Access Compliance Report

Public Rights-of-Way

(Curb Ramps)

Intersection ID: 5243	Main Street: CHIDLEY_DR	Cross Street: HUBBARD_RD	Location: NW
ADA ID: 6C58D6BB5FA3	Ramp Type: Perp	Initial Pass/Fail: Fail	Overall Compliance: No
		Severity Score: 25

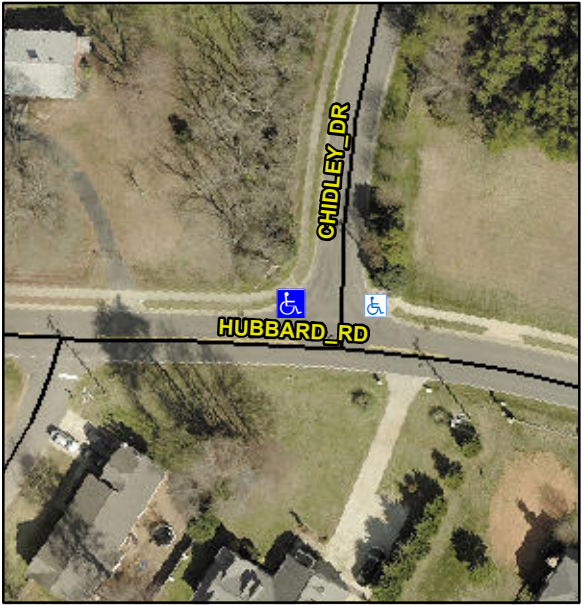
Codes/Mitigation Info/Possible Solution			Field Measurements/Component Compliance		
	Possible Solutions:		Compliance	Description	Data
	Remove & Replace Entire Ramp.		No	Ramp Length (in)	48.0
			Yes	Ramp Width (in)	60.0
			N/A	Flare Type LT	N/A
			N/A	Flare Slope LT (%)	N/A
			N/A	Flare Traversable LT?	N/A
			N/A	Landing Length (in)	N/A
			N/A	Landing Width (in)	N/A
			N/A	Landing Slope (%)	N/A
			N/A	Landing X Slope (%)	N/A
<p>Surveyor Notes:</p> <p>N/A</p> <p>PROW/ADA:</p> <p>R304.2.2</p>			N/A	Flare Type RT	N/A
			N/A	Flare Slope RT (%)	N/A
			N/A	Flare Traversable RT?	N/A
			N/A	DWS Provided?	N/A
			N/A	DWS Contrast?	N/A
			N/A	DWS Length (in)	N/A
			N/A	DWS Full Width?	N/A
			N/A	DWS Offset (in)	N/A
			N/A	Shared Landing?	N/A
			N/A	Gutter Ponding?	N/A
			N/A	Gutter Lip Ht (in)	N/A
			N/A	Painted X Walk1?	No
				X Walk 1 Direction	To E
			N/A	X Walk 1 Width (in)	N/A
				X Walk 1 Slope (%)	5.4
				X Walk 1 X Slope (%)	4.8

N/A	Ramp inside XWalk1?	N/A
			N/A	Road Slope (%)	N/A
			N/A	Road X Slope (%)	N/A
			N/A	Any Obstructions?	N/A
				Obstruction Type	
			N/A		
			N/A		
			N/A		
			N/A		
			N/A		
			N/A		
			N/A		
			N/A		
			N/A		
Total Cost:		\$ 1850.00			
			N/A		
			Yes	Surface Condition? (G/P)	Good
